[Docket No. NHTSA-2000-6940]

**Anthropomorphic Test Devices; Hybrid III 5th Percentile Female Test Dummy, Alpha Version; Final Rule; Response to Petitions for Reconsideration**

**ACTION:** Final rule; response to petitions for reconsideration.

**FIGURE O1**  
**NECK FLEXION TEST SETUP SPECIFICATIONS**

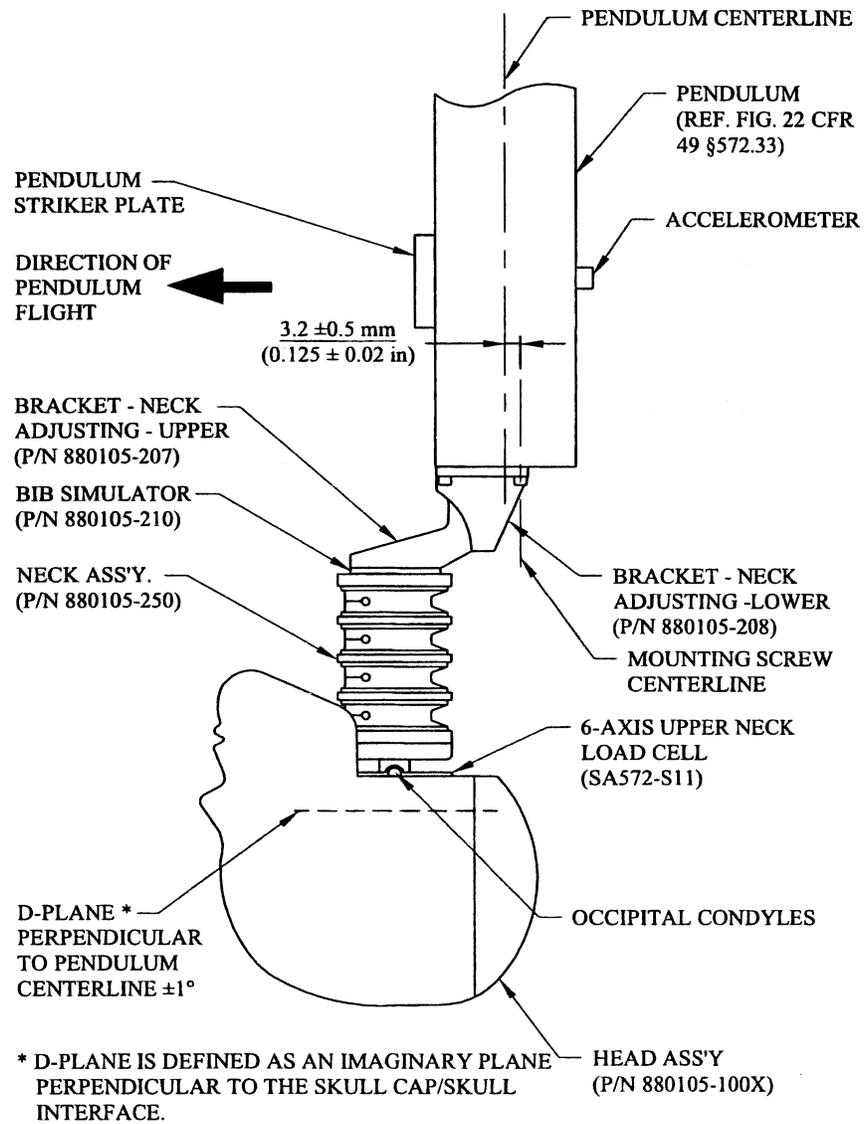
The Alliance noted that Figure O1 (*Neck Flexion Test Setup Specifications*) is missing the label for the lower neck-adjusting bracket. The Alliance also noted that the second label for the neck-adjusting bracket in Figure O2 (*Neck Extension Test Setup Specifications*) is incorrect. It should read: "BRACKET—NECK ADJUSTING—UPPER (P/N 880105-207)."

NHTSA agrees with all of these recommendations. The suggested changes reflect errors in the figures. Accordingly, the agency is revising Figure O1 by adding the missing label for the lower neck-adjusting bracket. That label will read "BRACKET—NECK ADJUSTING—LOWER (P/N 880105-208)." The agency is also revising the second label for the neck-adjusting bracket in Figure O2 to read: BRACKET—NECK ADJUSTING—UPPER (P/N 880105-207). The agency is changing the tolerance for the test probe alignment in Figure O3 from  $\pm 0.05$  degrees to  $\pm 0.5$  degrees, and the tolerance for the impact probe weight in Figures O3 and O5 from  $\pm 0.01$  kg (0.02 lb) to  $\pm 0.023$  kg (0.05 lb). Finally, the agency is adding the angle  $7 \pm 2$  degrees from the horizontal to the note Pelvic Angle Reference Surface in Figure O3.

FIGURE 03  
THORAX IMPACT TEST SETUP SPECIFICATIONS

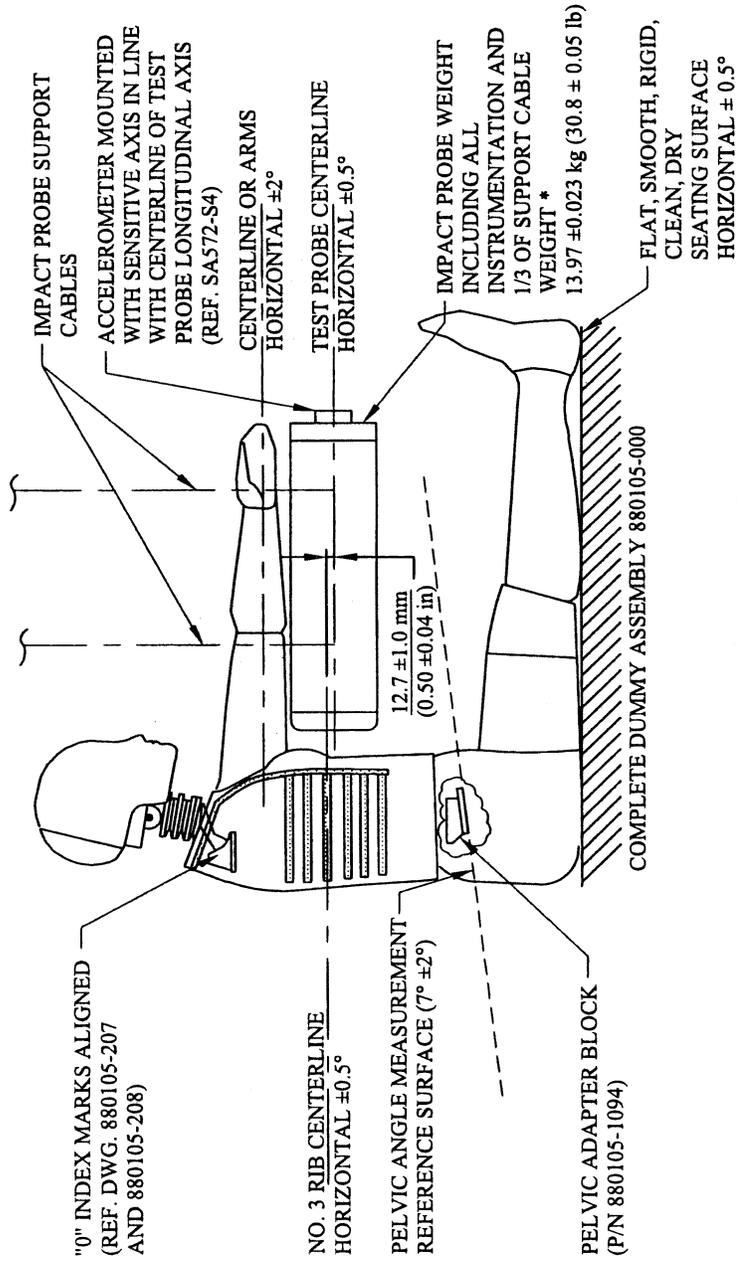
The Alliance and FTSS noted that some of the language in Figure O3 (*Thorax Impact Test Setup Specifications*) does not conform to the language in the final rule text.

Specifically, the Alliance and FTSS recommended that the agency change the tolerance for the test probe alignment from  $\pm 0.05$  degrees to  $\pm 0.5$  degrees, and the tolerance for the impact probe weight from  $\pm 0.01$  kg (0.02 lb) to  $\pm 0.023$  kg (0.05 lb) to conform to the text of the final rule. Finally, the Alliance and FTSS stated that Figure O3 does not contain a pelvic angle measurement. They noted that the Society for Automotive Engineers (SAE) Engineering Aid 25 specifies that the pelvis should be inclined rearward  $7 \pm 2$  degrees with respect to the horizontal. They recommended that this angle be added to the note Pelvic Angle Reference Surface" in Figure O3 so that testers will not be required to force the dummy's pelvis into an unnatural orientation.

**FIGURE O4**  
**TORSO FLEXION TEST SET UP SPECIFICATIONS**

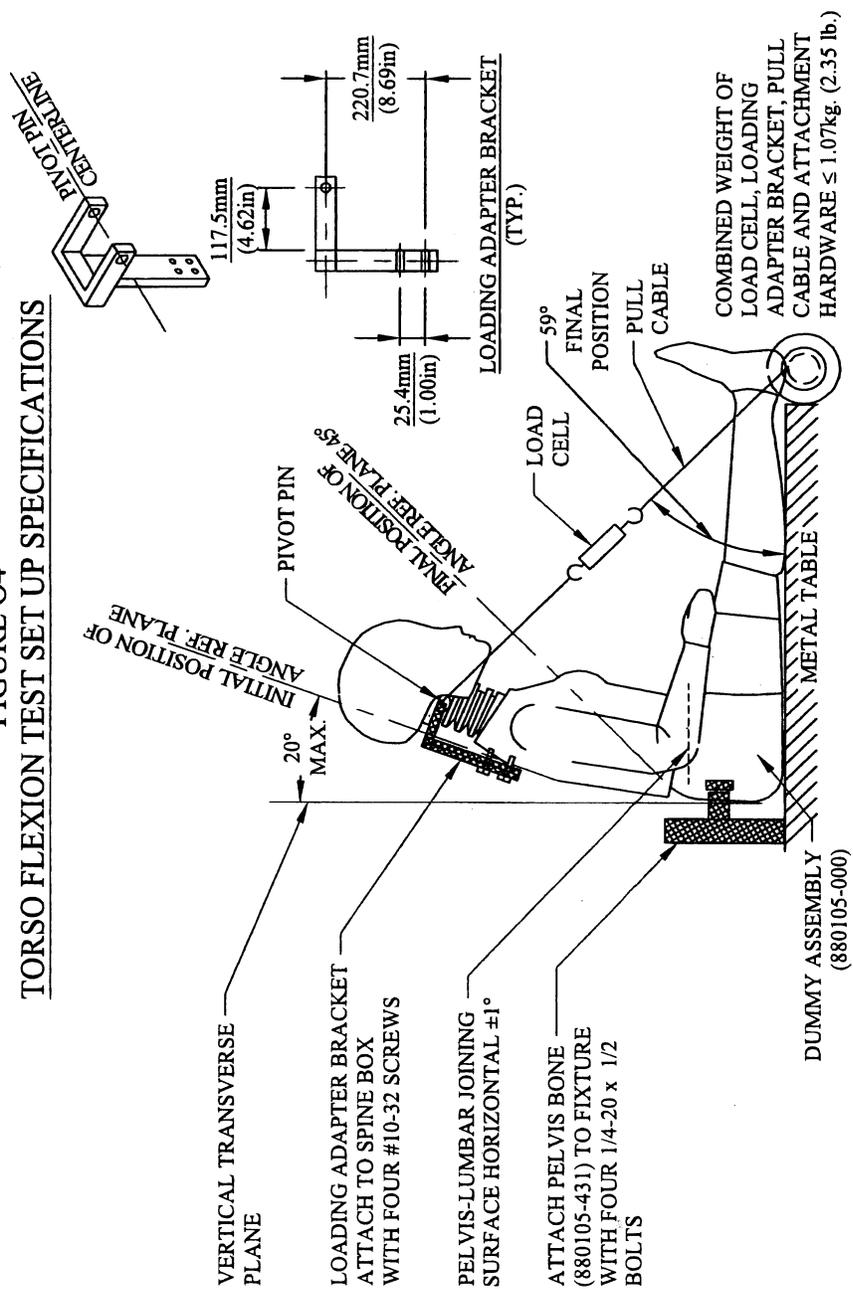
In reviewing Figure O4, NHTSA discovered that it had failed to specify the weight of the pull mechanism<sup>7</sup> used in the torso flexion test. The Hybrid III Six- and Three-Year-Old dummy requirements each specify the weight of the pull mechanism for the torso flexion test. To be consistent with those dummy requirements and assure test repeatability, the agency is specifying that the weight of the pull mechanism must be less than or equal to 1.07 kg (2.35 lb).

Accordingly, the agency is adding the following note to Figure O4: "Combined weight of load cell, loading adaptor bracket, pull cable, and attachment hardware 1.07 kg (2.35 lb).
